World Forum for Harmonization of Vehicle Regulations

Proposal for Supplement 7 to the 02 series of amendments to Regulation No. 129 (Enhanced Child Restraint Systems)

Submitted by the Working Party on Passive Safety *

Figure 3

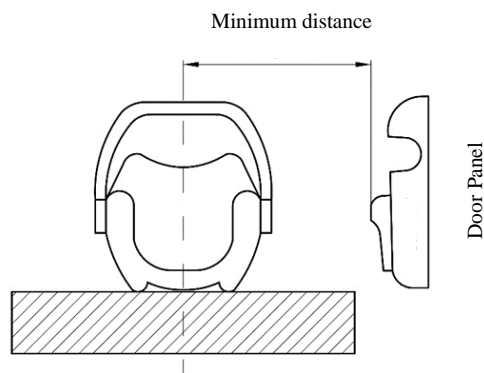
For each test, the initial position of the side impact door panel relative to the bench shall be adjusted according to the minimum distance between the vehicle's door panel and the centre of the seating position as shown in Figure 3.
